# Technical Service Bulletin

## 10 Oil loss from the filler cap

10 20 20 2059446/3 October 29, 2020. Supersedes Technical Service Bulletin Group 10 number 20-19 dated July 14, 2020 for reasons listed below.

**Figure 2.** Breather line for Supercharged V6.

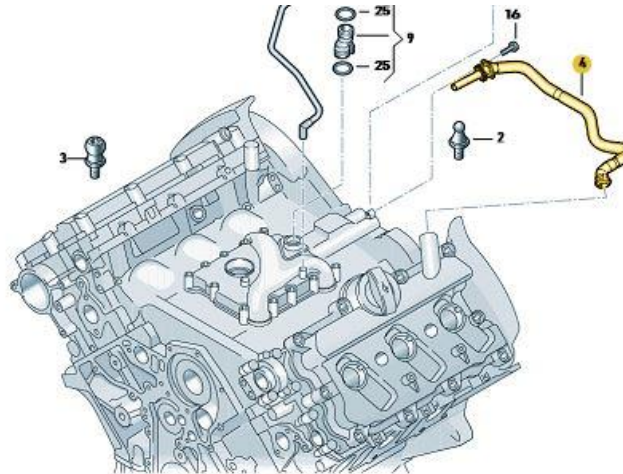
A faulty membrane in the breather line can result in excess pressure in the crankcase and therefore some oil loss through the filler cap.

Replace the breather line (different variants available, only order by VIN) (Figures 1 and 2).

A breather line with an improved membrane has been implemented in production.
